Issue Specific Hearing 10 (ISH10) on Biodiversity and Ecology

Theberton and Eastbridge Parish Council, B1122 Group and Stop Sizewell C

Oral Contribution by Cllr. Paul Collins

Edge of the HCDF and position of future footpath

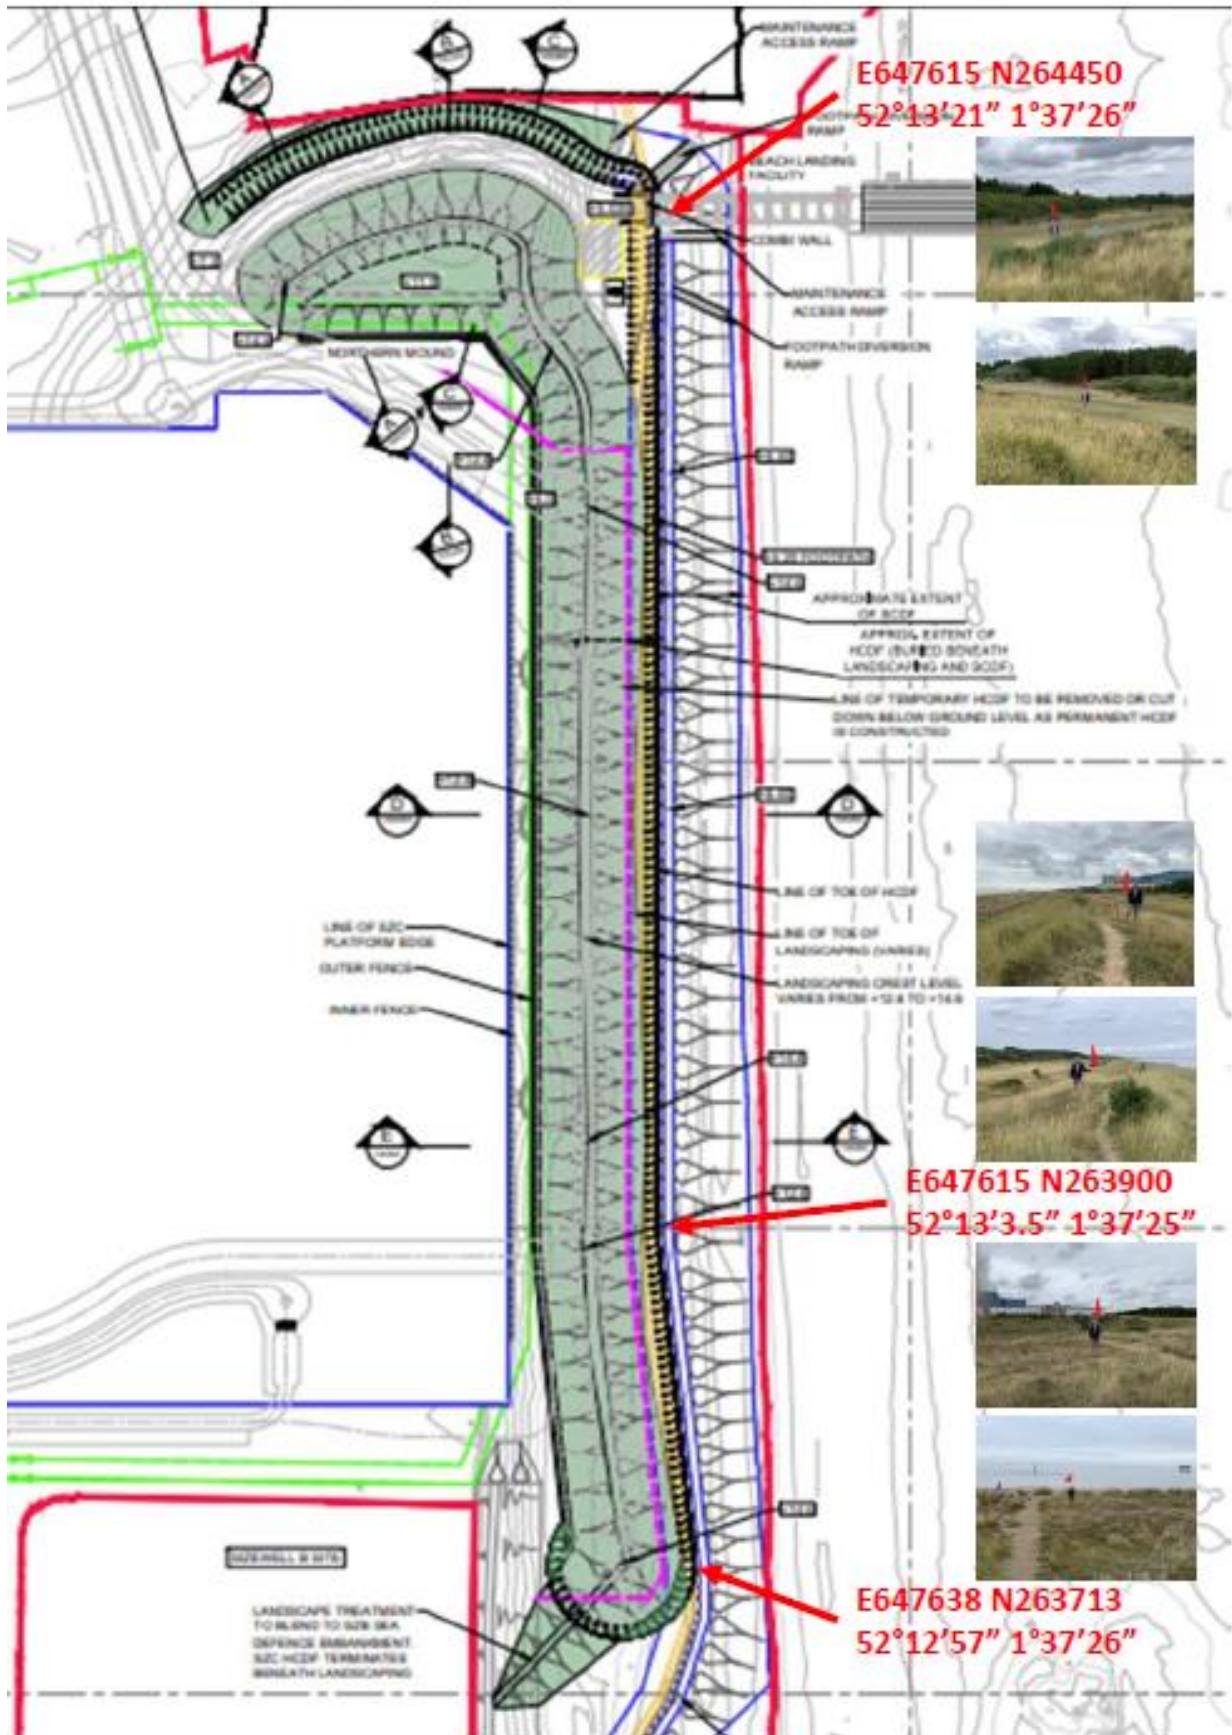
- **Of course the position of the BLF has recently been moved significantly towards the east so had that been marked for you, the exact position would have changed. The southern end has not changed. So on Monday 23rd August, I took the applicants latest plan having converted their Ordnance Survey references to compass northings and eastings to determine approximately where these two positions were, along with a point some 150-200m north of the southernmost point where there is the HCDF makes a slight turn eastward to finish it's travel to the BLF. The annotated map below shows the three positions with their compass points and with two pictures of the actual positions relative to the beach and the existing sacrificial dune. You will also note that the person in the picture is holding a thin pole with a red marker at the top. This roughly represents the level that the coastal path will be relative to the existing ground. It should be noted that to the seaward side of those positions the new sacrificial dune and shingle beach will be an additional metre higher. A snapshot of the document is given below but the original with the original high resolution photographs will be submitted separately.**

- **From the southernmost position, the pictures clearly show the extent to which the HCDF toe and built up defence will completely remove the large area of vegetated shingle on the SZB hydraulic groyne. You can see the SZB outfall in the distance in one of the two photos and the other looks back to the existing sacrificial dune.**

- **The middle point at the "inflexion" point of the HCDF toe is right on the existing sacrificial dune apex.**
- **The BLF point actually now sits behind the current sacrificial dune having been brought westward by the recent redesign.**
